**RE:** Balboa Reservoir – Design Review Update

This memorandum summarizes design review comments and feedback from Planning Department staff on the most recent Balboa Reservoir sketch draft (discussed on September 20, 2018). Since many comments from the August 21<sup>st</sup> design review memorandum still apply, they are copied below for ease of reference. Presuming that Reservoir Community Partners is further developing the Sept 20<sup>th</sup> sketch, this memorandum supersedes the August 21<sup>st</sup> memorandum. While the entire memorandum should be taken into account, the core of the Department's original feedback is in **bold text** for clearer guidance. New comments based on the most recent sketch are **highlighted** below.

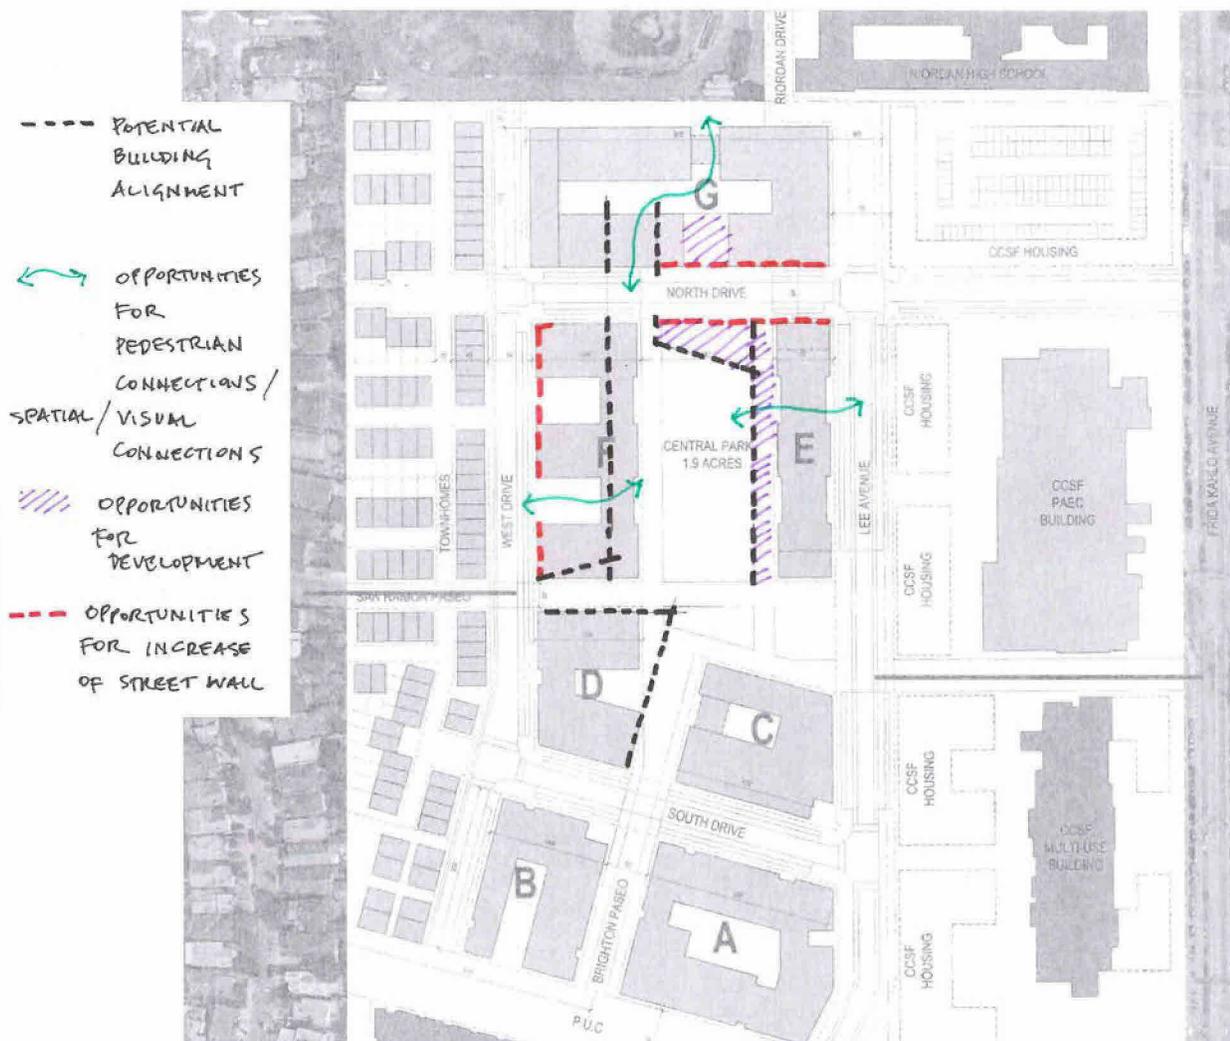
The reconfiguration of the open space and the design responses to ongoing feedback from City College and the neighborhood are both supported. But parcels E, F, and G could benefit from being less rigid and from more balanced proportions. Specifically, the Planning Department recommends:

- Revising Parcels E and F so their widths are balanced and centering the central park between West Drive and Lee Avenue;
- Finding opportunities to express the different angles/ alignments originally caused by Ocean Avenue/ PUC alignments deeper into the site (i.e. parcels E and F);
- Shifting the green/open space connection on parcel G to the west;
- Exploring a larger footprint for parcel E to create a stronger street frontage along North Drive.
- Adding pedestrian connections and/or visual connections on parcels, E, F, and G; and ensuring the space north of parcel G does not feel isolated or unsafe
- Further defining Brighton Paseo with the footprint of parcel D;
- Creating a strong street frontage at North Drive and West Drive.
